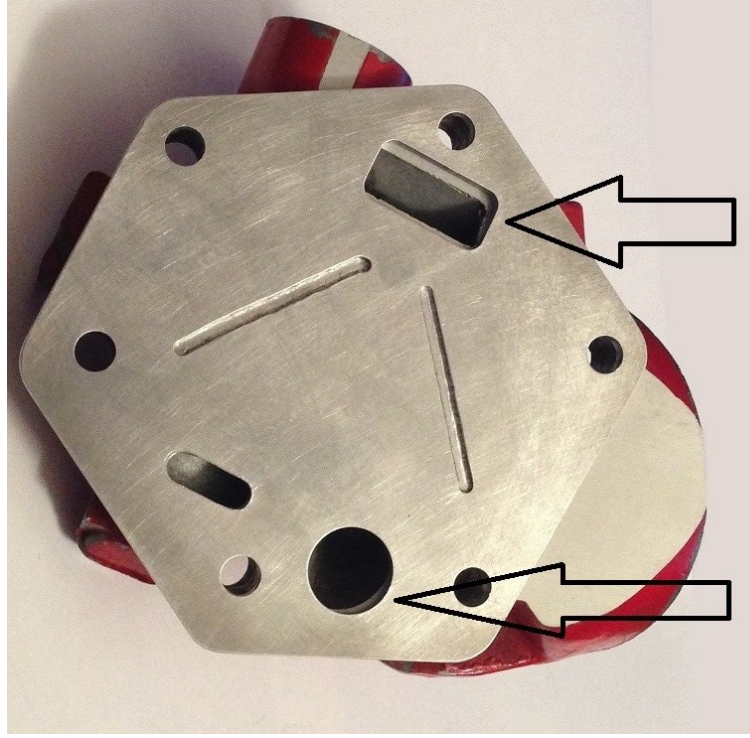
**DO NOT USE GASKET "A"
THAT DOES NOT HAVE
PASSAGE LIKE GASKET "B"**

ON EITHER SIDE OF PLATE

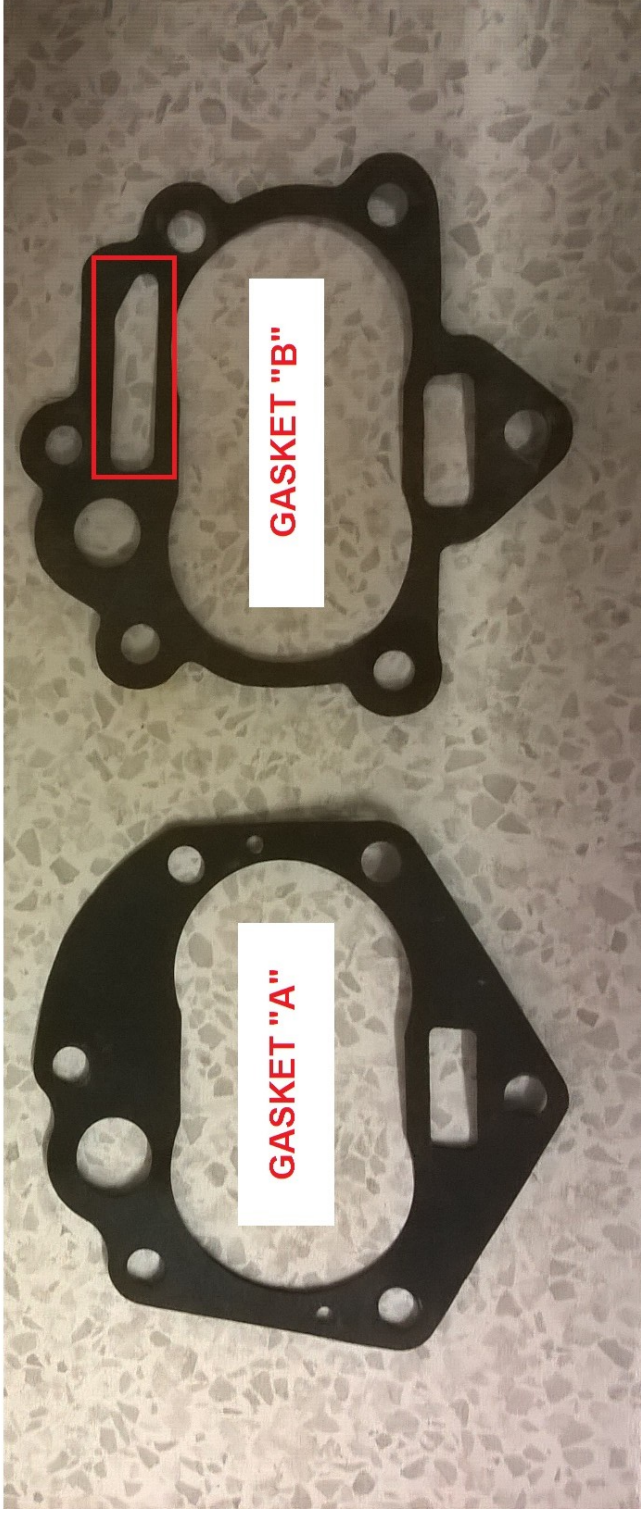
BLEND COVER AT ARROWS

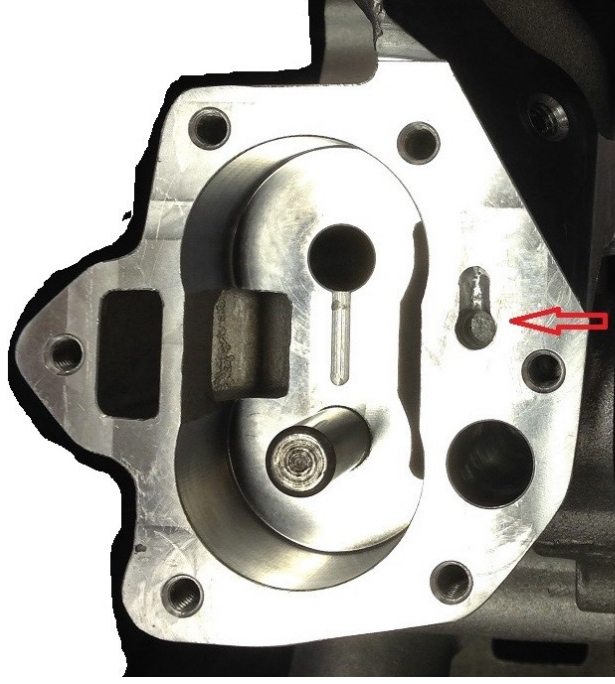
**If 455 T/A timing cover does not
have this 1/4" hole it must be drilled**
